Environment Agency permitting decisions

Bespoke Variation (Substantial)

We have decided to issue the variation for Snodland Paper Mill operated by Smurfit Kappa UK Ltd.

The variation number is EPR/BJ7433IQ/V004

Peter's Pit - Annual Average NO_x contour plot

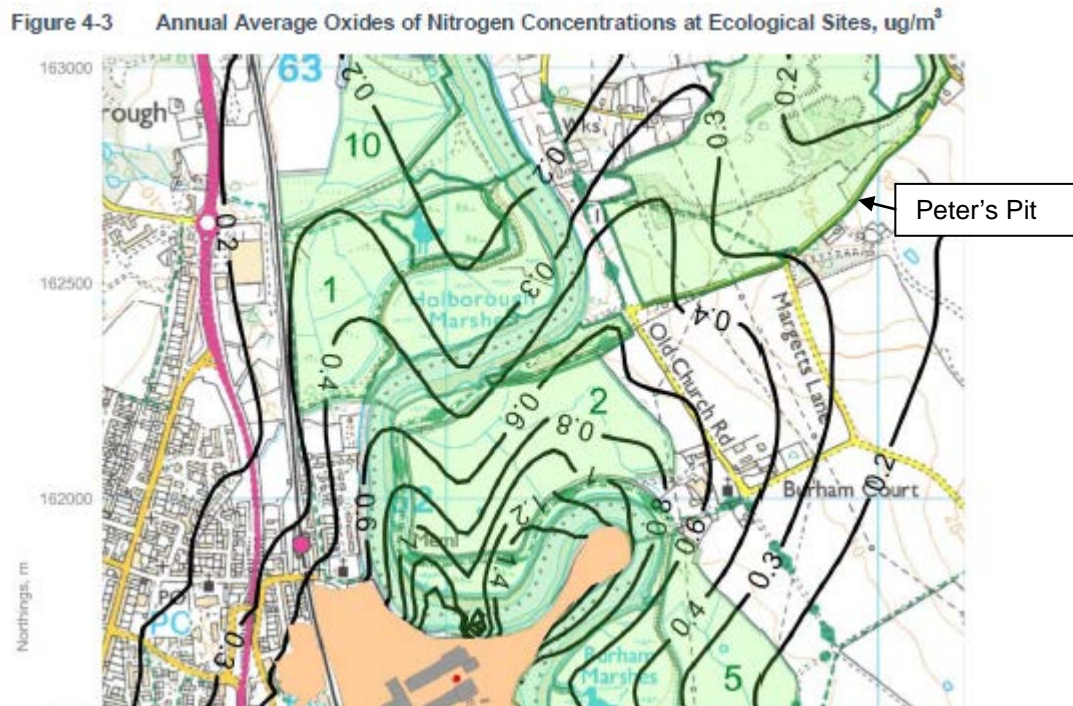
Looking at the criteria for Peter's Pit SSSI status, Nitrogen Deposition does not screen out because in this location the background concentration is currently exceeding the appropriate environmental criterion and the new process contribution will cause an additional small increase. We consider that this small additional impact is not significant with respect to the existing levels. The calculation of nitrogen deposition is derived from the Annual Average NO_x concentration - in this case the highest figure for Peters Pit was used for the deposition calculation (0.51 µg/m³). An extract of the contour plot of NO_x concentrations at Peters Pit (Figure 4-3 below) shows that this level is likely only in the southwest part of the SSSI, and that levels across the majority of the site will be lower. As stated above is designated primarily for Great Crested Newts (*T. cristatus*). APIS does not provide critical load data for nitrogen deposition for *T. cristatus*, which are not directly impacted by high levels on nitrogen. Emission limits will be placed on the engines in the permit to ensure compliance with the proposed emissions used in the assessment.
